UNITED STATES PATENT AND TRADEMARK OFFICE

APPLICATION NO.	FILING DATE	FIRST NAMED INVENTOR	ATTORNEY DOCKET NO.	CONFIRMATION NO.
10/820,134	04/08/2004	Han Jun Sung	1594.1364	6666

Office Action Summary	Application No. 10/820,134	Applicant(s) SUNG ET AL.	
	Examiner Michael J. Early	Art Unit 3744

DETAILED ACTION

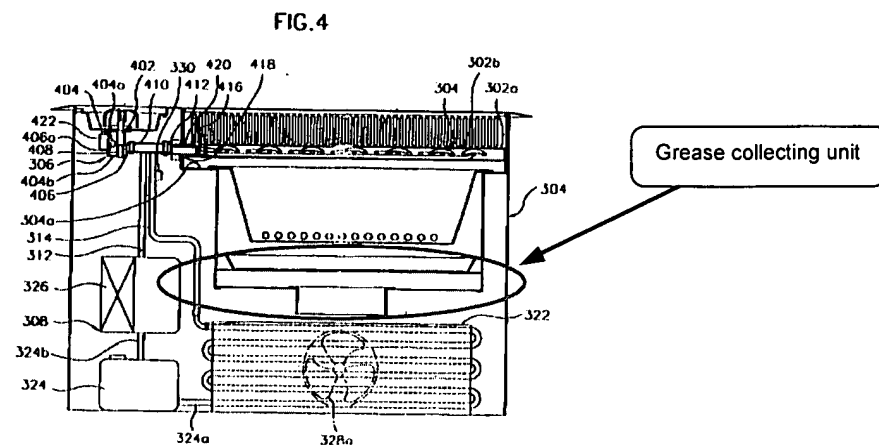
Regarding claim 10, Lee et al. disclose a grease collecting unit (as seen in the first illustration of Figure 4 below), provided in the cabinet under the grilling unit (as seen in Figure 4), to collect grease and sauces dripping from the food that is placed on the grilling unit during grilling of the food (as seen in Figure 4).

(Partial illustration of Figure 34)

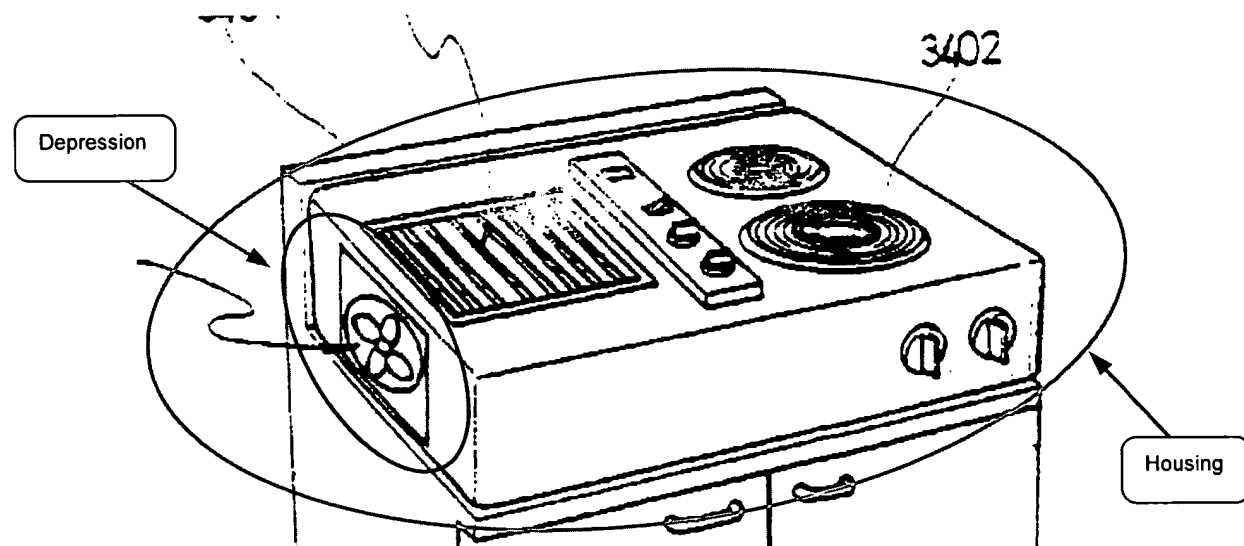
Regarding claim 13, Lee et al. disclose a multipurpose cooking apparatus (3400 – gas range; Figure 34), comprising a housing (as seen in the partial illustration of Figure 34 below) having at least one recess (1204a – accommodating portion) on an upper portion of the housing (as seen in Figures 4, 12a, 34); and a grill cooker (30 – meat roaster; col. 11, line 61 – col. 12, line 6) removably seated in the at least one recess (as seen in Figures 4, 12a, 34), the grill cooker comprising a heating unit (430 – heat source) generating heat to grill food (see col. 6, lines 33-36; col. 12, lines 2-6), a grilling unit (3404 – grill) provided above the heating unit (as seen in Figures 4, 34), with the food placed on the grilling unit (see col. 11, line 61-64), the grilling unit comprising at least one grilling pipe (3403a – fluid circulating pipe) above the heating unit (as seen in Figure 4, 34) and comprising an inlet (302c – inlet socket) and an outlet (302d – outlet socket), and a cooling unit (308, 3206, 3406 – temperature controller; col. 5, lines 1-3; col. 11, lines 45-49 and 58-60) connected to the grilling unit to cool the grilling unit using a fluid (see col. 4, line 63 – col. 5, line 14; col. 11, lines 56-60).

Regarding claim 17, Lee et al. disclose a depression (as seen in the partial illustration of Figure 34 above) on a lower surface of the recess to receive the air cooling unit of the grill cooker (as seen in Figures 4, 12a, 34), with a air hole on a surface of the depression (as seen in Figure 34) to draw air into the cooling unit (as seen in Figure 34) to allow the grilling unit to be cooled by the air (indirectly) when the grill cooker is set in the recess, the cooling unit being received in the depression (as seen in Figure 34).

Regarding claim 18, Lee et al. further disclose the air cooling unit extends downward from the lower portion of the cabinet and is received by the depression (as seen in Figure 34).
